ECE/TRANS/WP.29/GRSP/2009/21  
24 September 2009

GLOBAL TECHNICAL REGULATION No. 9  
(Pedestrian safety)

Phase 2 of the global technical regulation - flexible legform impactor

Proposal to develop amendments to global technical regulation No. 9 (pedestrian safety)

**Figure 35: Test set-up for knee joint in static certification test (see paragraph 8.2.1.5.)**

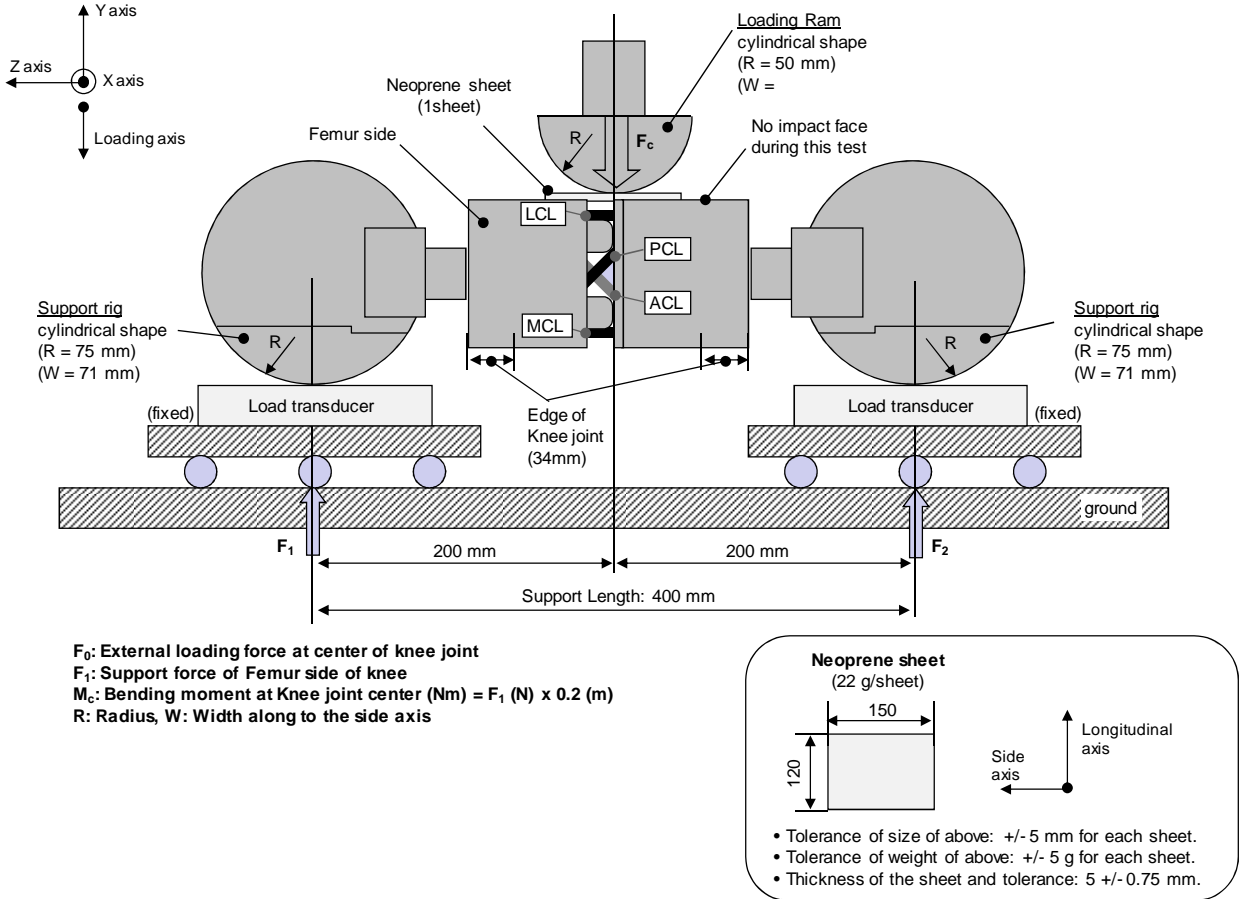
**8.2.1.5.** The edges of the knee joint, not bending parts, shall be mounted to the support rig firmly as shown in Figure 35. The Y axis of the impactor shall be parallel to the loading axis within  $180 \pm 2^\circ$ . In order to avoid friction errors, roller plates shall be set underneath the support rigs. To avoid impactor damage, a neoprene sheet shall be set underneath the loading ram and the impactor face of the knee joint which is described in the Figure 14 shall be removed. The neoprene sheet used in this test shall have compression characteristics as shown in Figure 16.

The centre of the loading force shall be applied at the centre of the knee joint within  $\pm 2^\circ$  tolerance along the Z axis. The external load shall be increased at a rate between 10 and 100 mm/minute until the bending moment at the centre part of the knee joint ( $M_c$ ) reaches 300 Nm.

**Figure 36:** Test set-up for dynamic lower legform impactor certification test, Pendulum type (see paragraph 8.2.2.4.)

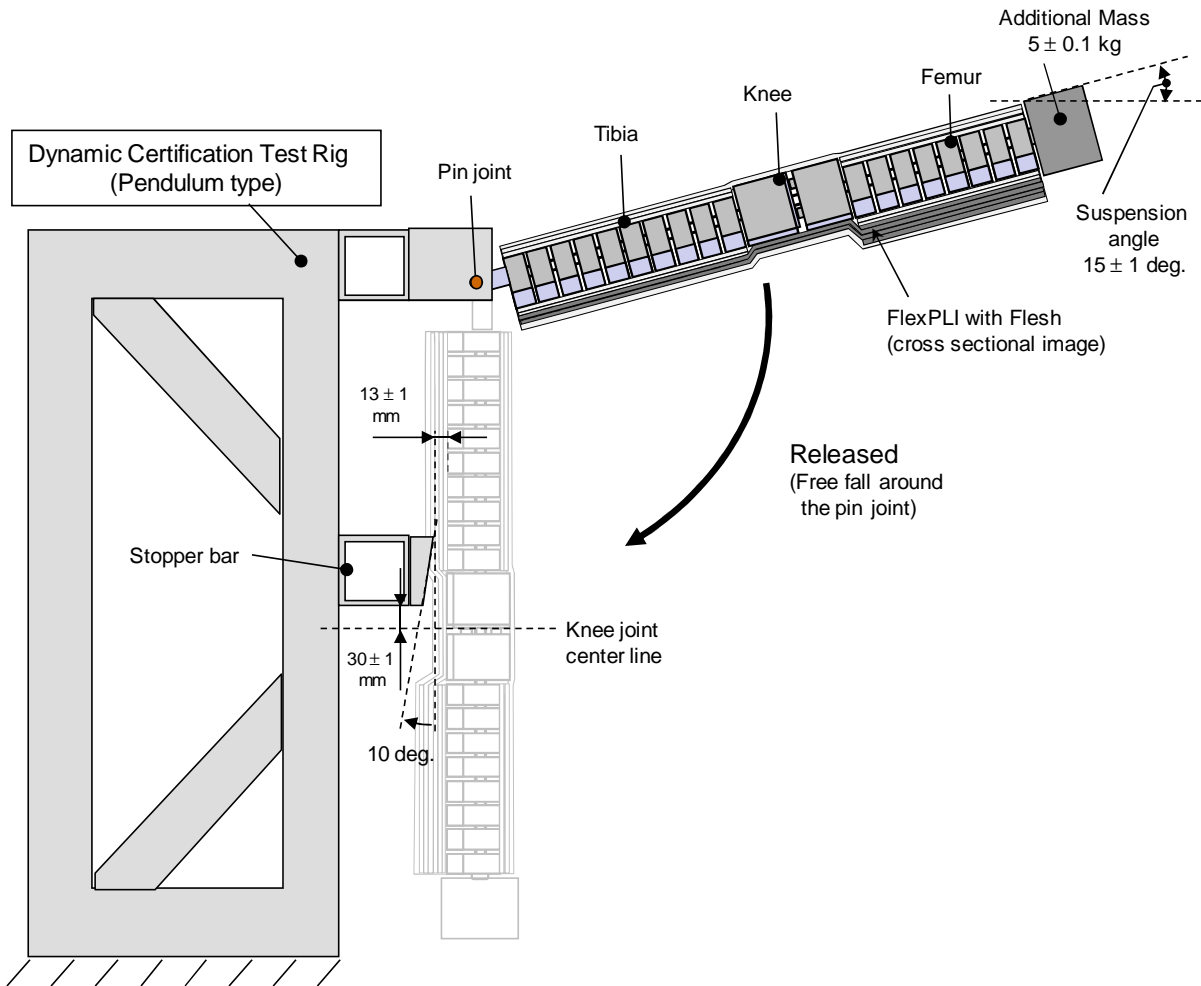
8.2.2.4.1. The impactor, excluding flesh, shall be suspended from the dynamic certification test rig  $15 \pm 1^\circ$  upward from the horizontal as shown in Figure 36. The impactor shall be released from the suspended position, whereupon the impactor falls freely against the pin joint of the test rig as shown in Figure 36.

8.2.2.4.2. The knee joint centre of the impactor shall be  $30 \pm 1$  mm below the bottom line of the stopper bar, and the tibia impact face shall be located  $13 \pm 1$  mm from the front upper edge of the stopper bar when the stopper block is removed from the stopper bar and then hung from the impactor without any contact (see Figure 36).

**Figure 37: Test set-up for dynamic lower legform impactor certification test, Inverse type (see paragraph 8.2.3.4.)**

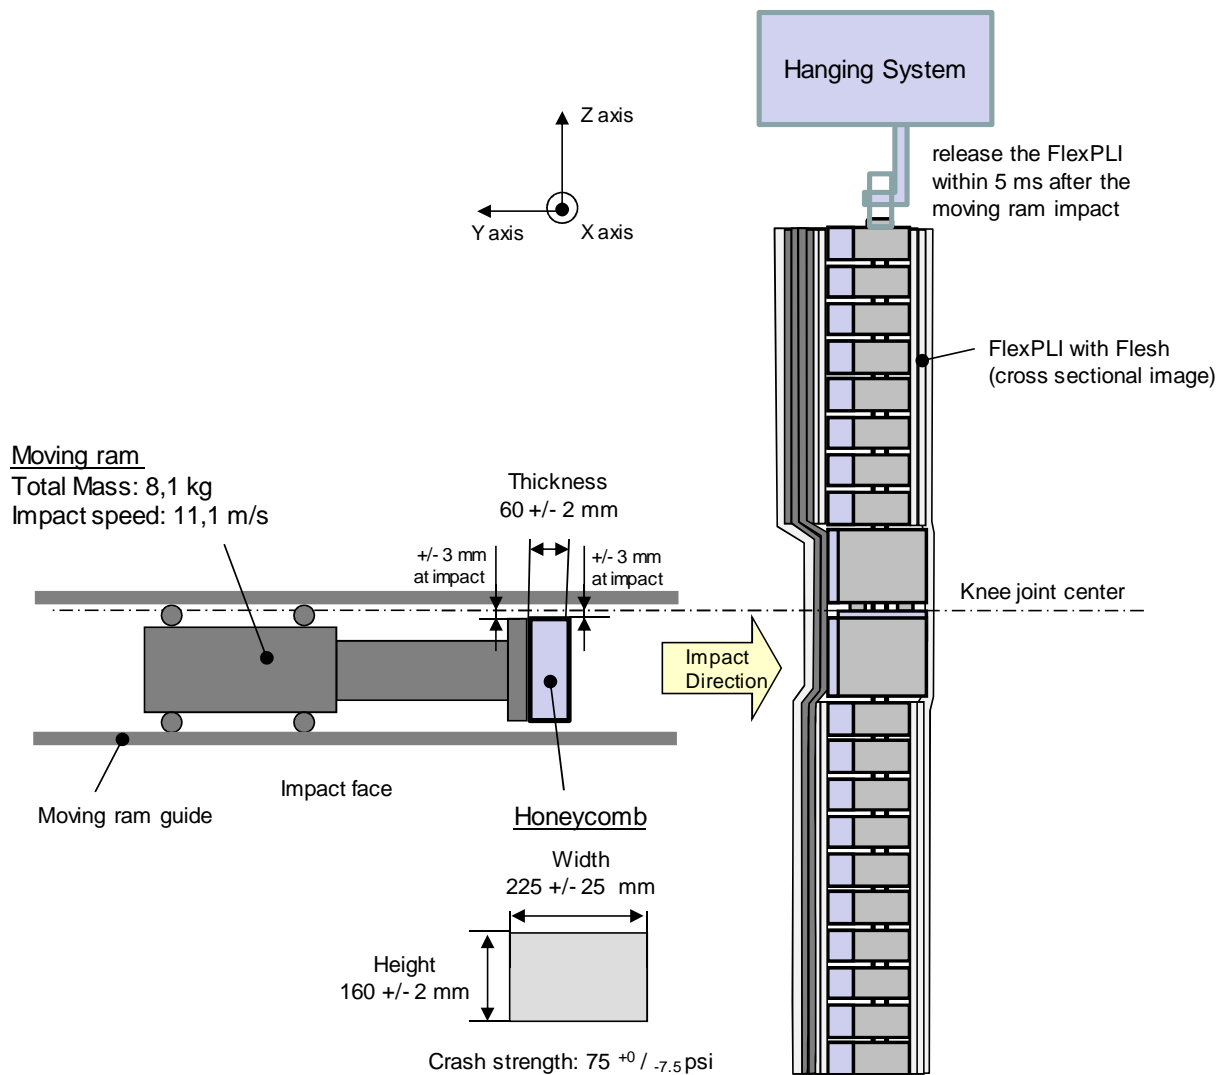
**8.2.3.4.1.** The impactor covered by flesh shall be hung vertically as shown in Figure 37. The impactor shall be impacted by a moving ram of  $8.1 \pm 0.1$  kg mass, at an impact speed of  $11.1 \pm 0.2$  m/s. The impactor shall be released from the hanging system within 5 ms after the moving ram impacts the impactor.
